DATE: December 15, 1969

SUBJECT: Main Landing Gear Bracket Inspection

MODELS AFFECTED: AAL-0002 thru AAL-0008, AAL-0011 thru AAL-0014

Figure 1. Right-Hand Main Landing Gear Bracket

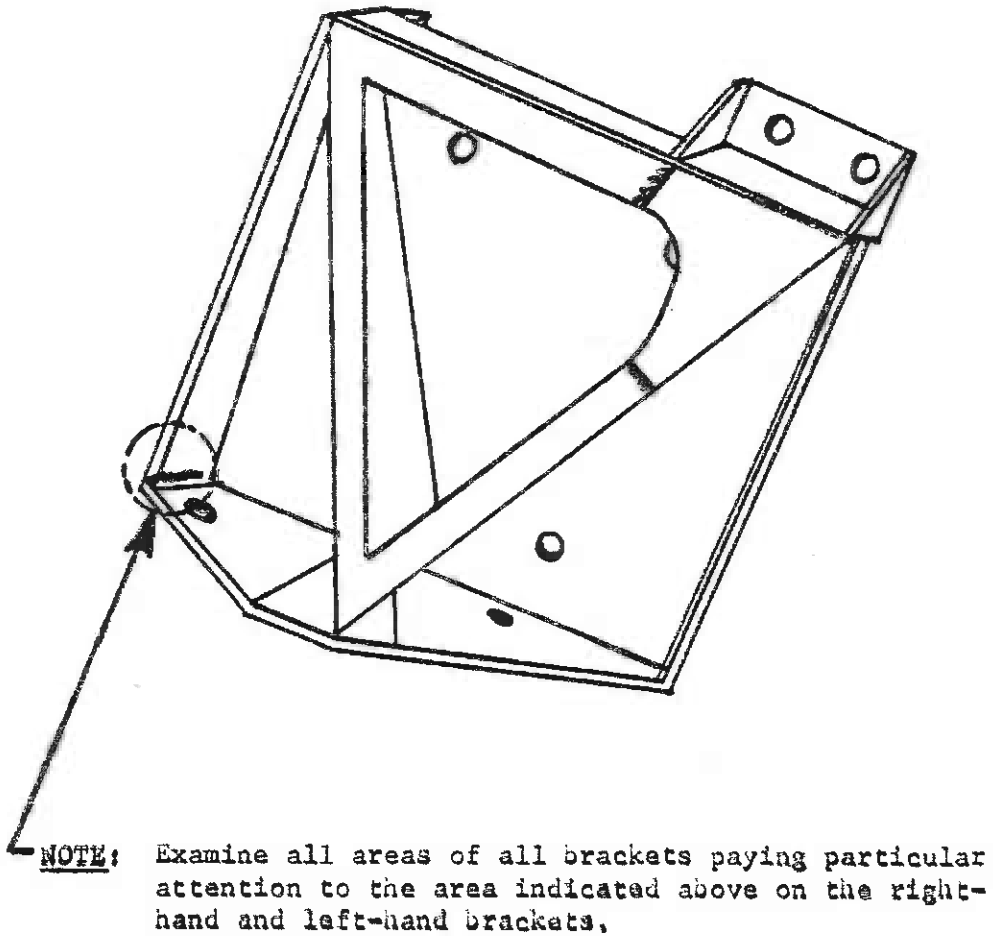
Field reports indicate that upper main landing gear brackets installed on above aircraft may be subject to cracking in the area of the welded joints. To confirm the structural integrity of brackets installed on these aircraft, the following must be accomplished within 25 hours of operation and at each subsequent 100 hour inspection.

NOTE: The upper main landing gear brackets are heat treated and if cracks or damage are found, DO NOT WELD. The brackets must be replaced.

1. Visually inspect upper main landing gear welded brackets for evidence of cracks.
2. Complete the enclosed Service Reply Card showing compliance with this bulletin and showing aircraft hours and forward card to American Aviation Corporation.
3. Complete a log book entry indicating compliance with this bulletin.

Service Kit No. SK-108 (Main Landing Gear Modification) has been developed to assist in changing brackets in the field. Service Kit No. SK-108 includes new brackets and all hardware and instructions for field retrofit of both the right and left upper gear brackets. This kit must be installed on all aircraft on which cracked brackets are found. Brackets removed from affected aircraft must be returned to the factory.
